CONSTRUCTION SUMMARY
EARLGLEN INVESTMENTS INC.

LOT NUMBER	PHASE	HOUSE TYPE	CLOSING DATE
111 BLOCK 018	1	THE ELIZABETH(CORNER)-ELEV B-3 BDRM-2 BATHS	05-May-26

Date Added: 03-Jun-25 Invoice Number: 8813

Revised
Primary Bedroom

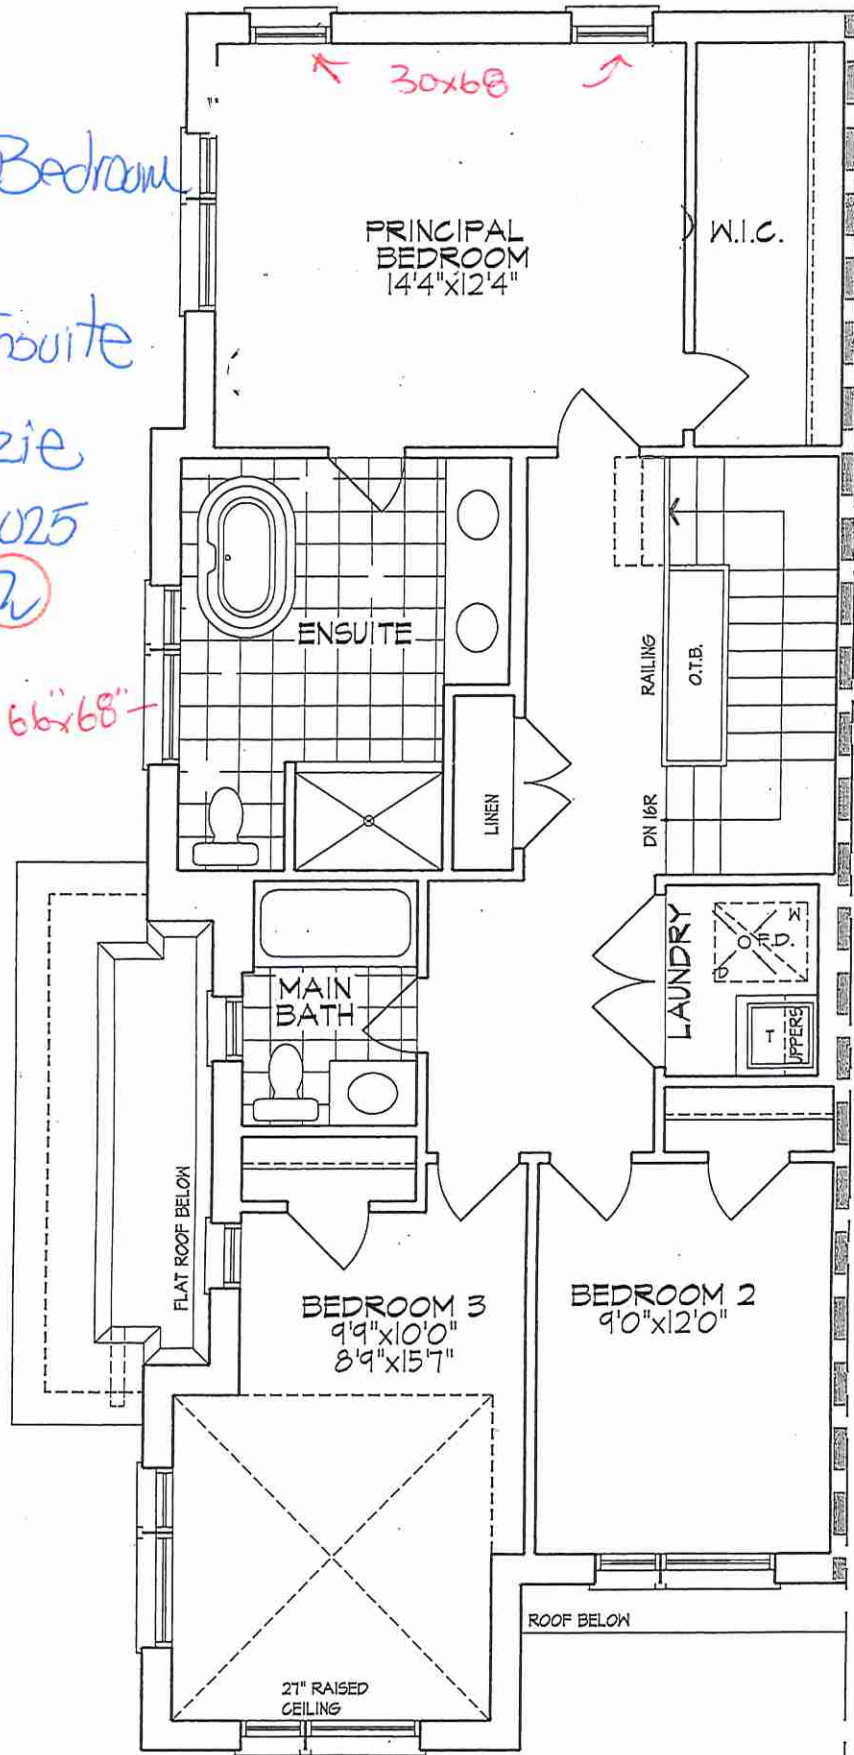
1 - Install Builders Standard Cable Rough-Ins (x2) and Install Builders Standard Telephone Rough-Ins (x2) (See Sketch) Note:
1 - PRIMARY BEDROOM - In addition builders standard electrical outlets, Install ADDITIONAL TWO (x2) ELECTRICAL OUTLETS at Primary Bedroom (See Sketch) Note: **No Charge as per Fonzie C.**
1 - PRIMARY BEDROOM - Delete standard closets at primary bedroom. Install Walk-In Closet at primary bedroom. Windows at back elevation to be reduced. Bedroom size to be reduced to accommodate walk-in closet (See Attached Revised Layout) Note: **No Charge As per Fonzie C.**
1 - PRIMARY ENSUITE - Install Standard Free Standing tub STRAIGHT. Delete two standard windows at front elevation and Install ONE (1) Window centred at front elevation of primary ensuite (See Attached Revised Layout) Note: **No Charge As per Fonzie C.**
1 - 2ND FLOOR - CEILINGS - Install UPGRADE SMOOTH CEILINGS - To be installed throughout 2nd floor, where applicable. To Include; Upper Hall, Primary Bedroom, Bedroom #2 and Bedroom #3 (See Sketch) Note:

cable - (C) (x2)
 telephone - (T) (x2)
 Conduit (x1)
 Electrical - (E) (x2)

KITCHEN PLAN

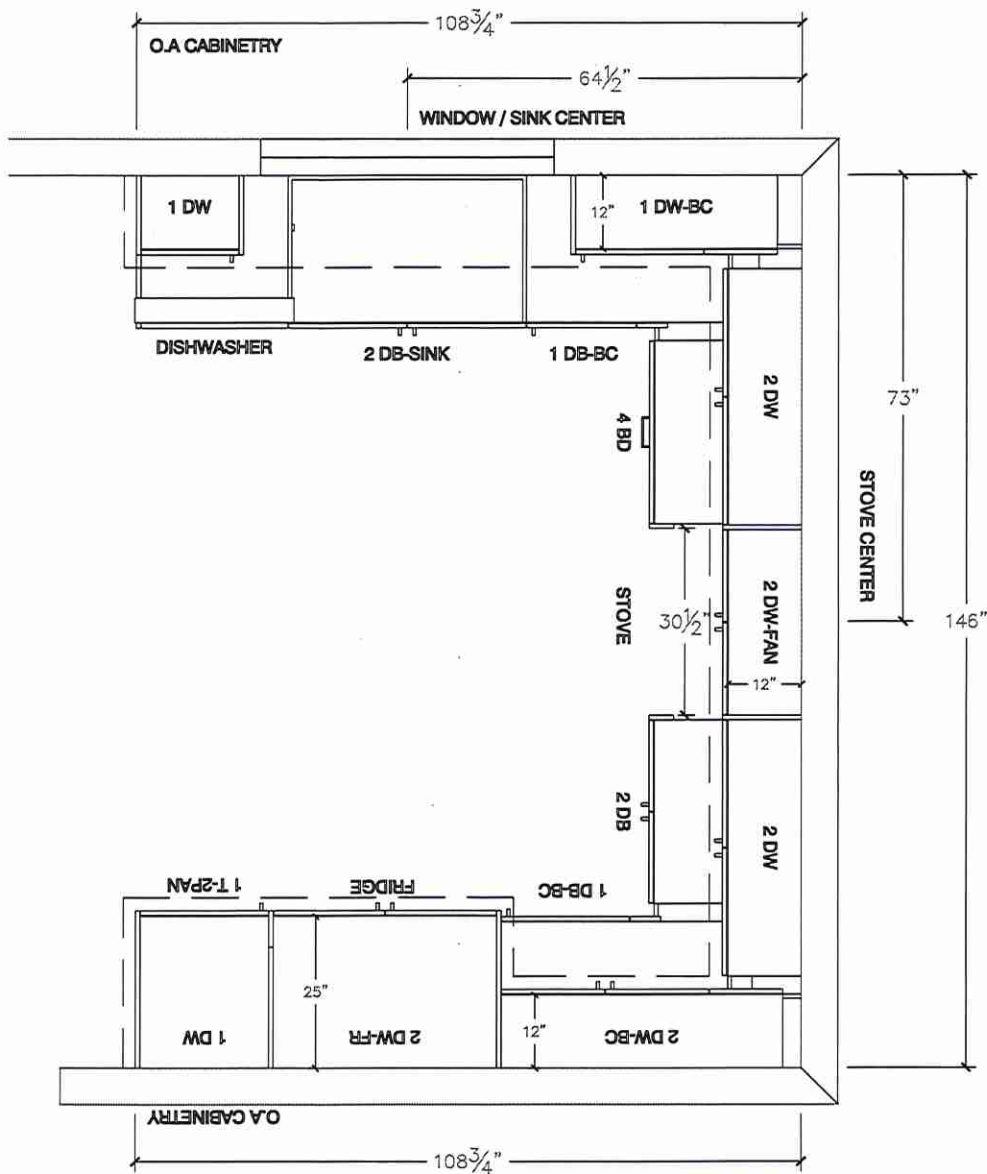
* WINDOW CENTER TO BE MOVED AT 64.5"
